Subject: PSB E274: PACCAR MX-13 Engine Model Year 2019-2020 Oil Filter Cap Replacement

## Technical Information Bulletin

### E274

PACCAR MX-13 EPA17 EMY2019-2020 Oil Filter Cap Replacement

Figure 2 Example of a filter with no significant debris

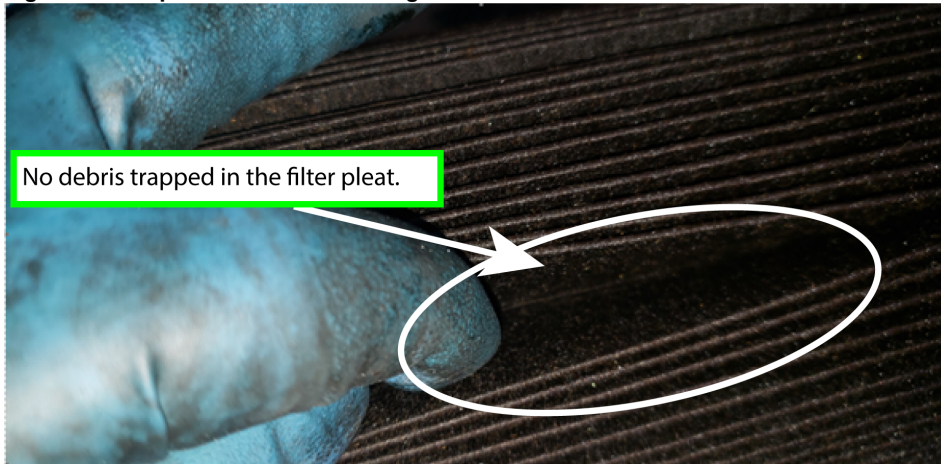
1. On the Engine Oil Module, remove the filter cap.
2. Remove the oil filter cartridge.
3. Carefully, without damaging the filter, inspect the oil filter cartridge pleats for debris, separation at the seam, or tears in the pleats. If significant debris is found, take clear photos.
  - A replacement filter is not included for this repair.
  - Significant debris includes
    - Non-ferrous material
    - Aluminum
    - Irregularly-shaped material

Figure 3 Example of a filter with significant debris

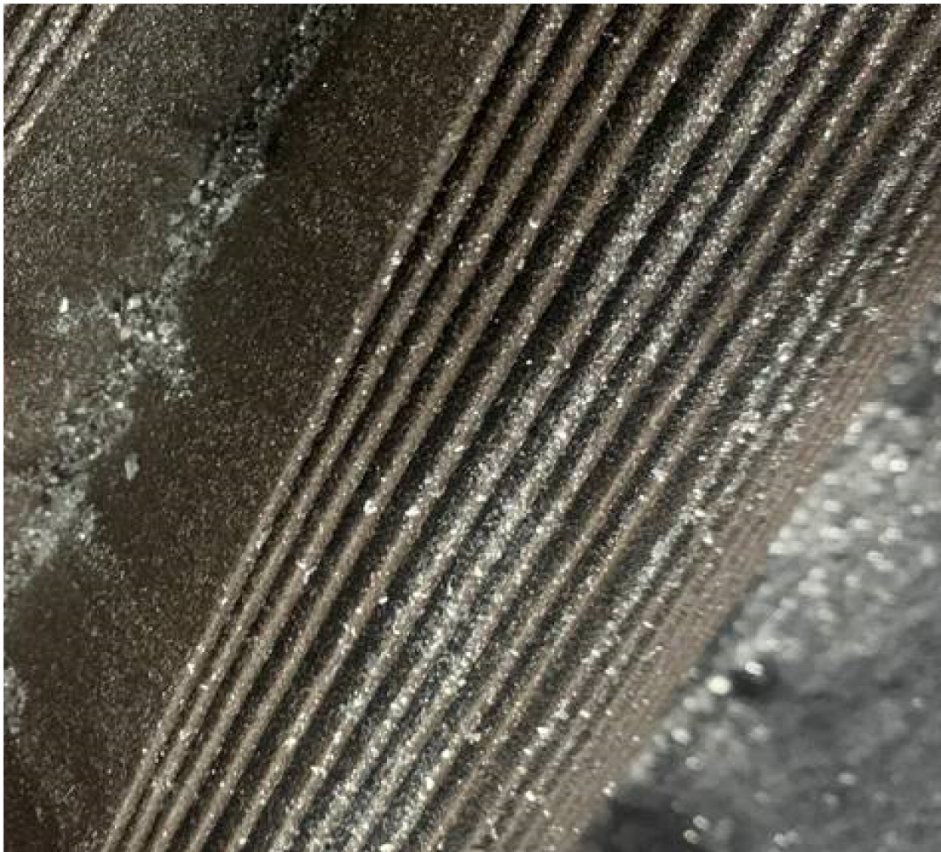
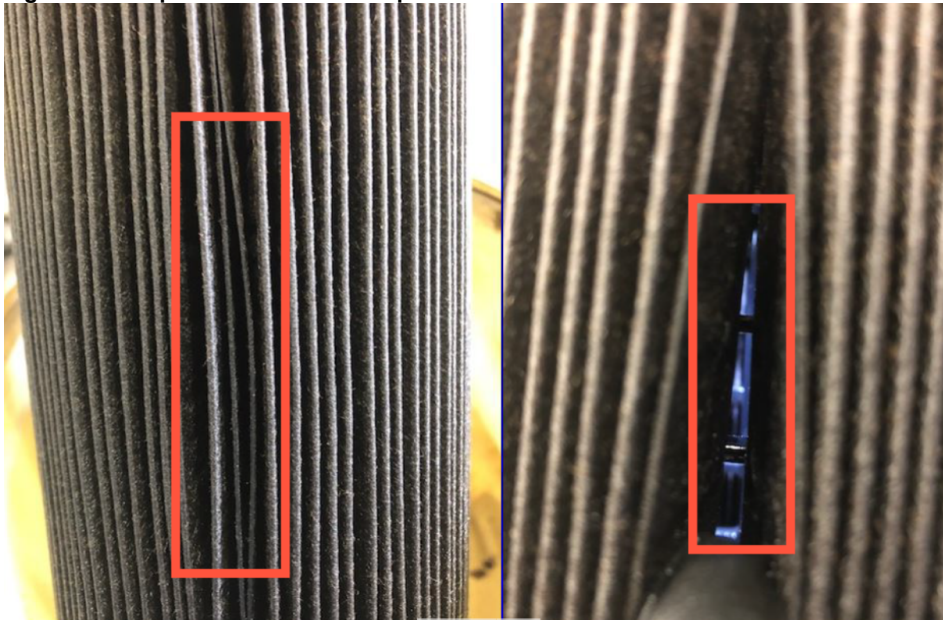
Large debris trapped in the filter pleat.

5. If there are no issues found, install the new oil filter cap with the original oil filter.
6. If broken bypass valve tabs are found or significant debris is found in the filter pleats, start a TCS365 case and await instructions from the VSC. Provide the following information in the case:
- If tabs are broken
  - If significant debris was found in the filter pleats
  - If a separated seam is found. In addition, take an oil sample and return the oil sample and filter to PTC.
  - If a damaged pleat is found. In addition, take an oil sample and return the oil sample and filter to PTC.
  - Attach photos

**Figure 5 Oil filter cap cut-away**

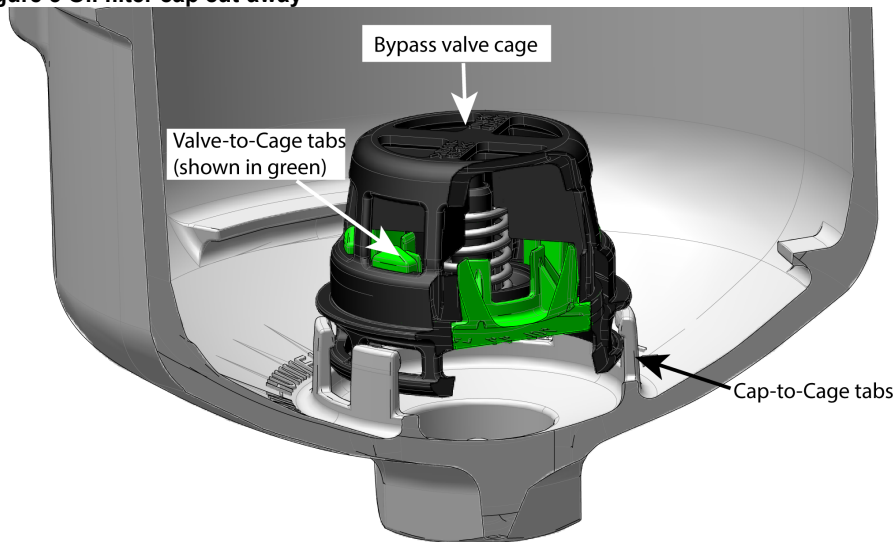
4. Inspect the retaining tabs that hold the bypass valve cage to the filter cap and the tabs that hold the bypass valve to the cage. If any of them are broken, take clear photos.
- Tip: Ensure the camera flash is on or use a flashlight to illuminate the bypass valve.

**Figure 3 Example of a filter with significant debris**

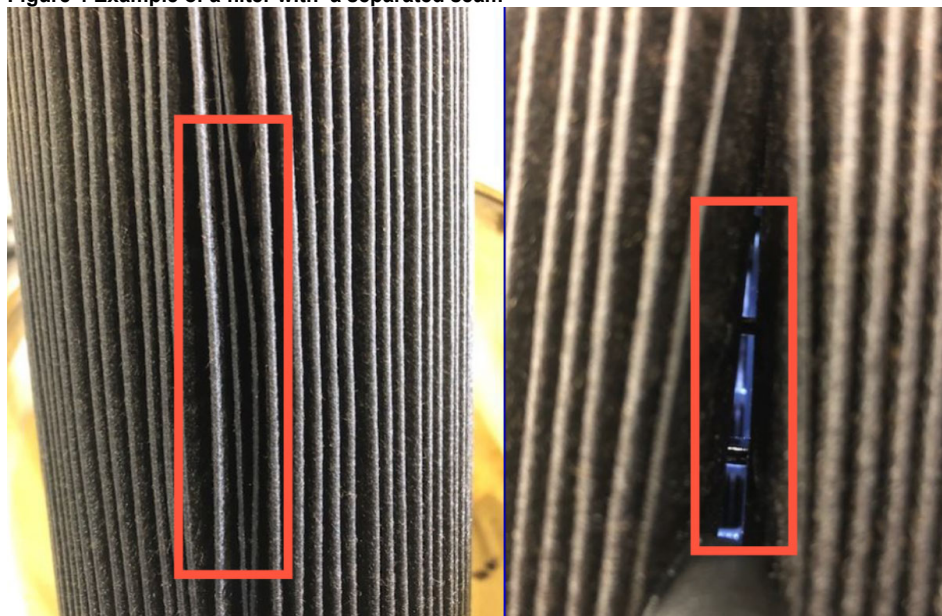
Large debris trapped in the filter pleat.

5. If there are no issues found, install the new oil filter cap with the original oil filter.
6. If broken bypass valve tabs are found or significant debris is found in the filter pleats, start a TCS365 case and await instructions from the VSC. Provide the following information in the case:
  - If tabs are broken
  - If significant debris was found in the filter pleats
  - If a separated seam is found. In addition, take an oil sample and return the oil sample and filter to PTC.
  - If a damaged pleat is found. In addition, take an oil sample and return the oil sample and filter to PTC.
  - Attach photos

Figure 4 Example of a filter with a separated seam

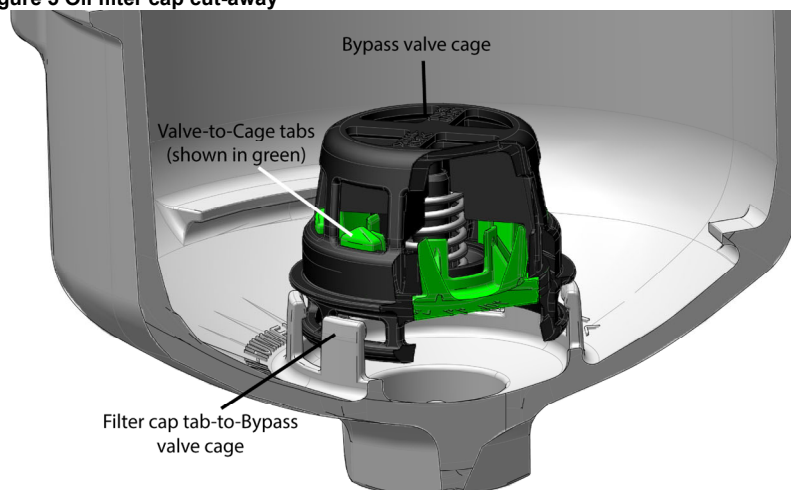
1. On the Engine Oil Module, remove the filter cap.
2. Remove the oil filter cartridge.
3. Carefully, without damaging the filter, inspect the oil filter cartridge pleats for debris, separation at the seam, or tears in the pleats. If significant debris is found, take clear photos.
  - A replacement filter is not included for this repair.
  - Significant debris includes
    - Non-ferrous material
    - Aluminum
    - Irregularly-shaped material
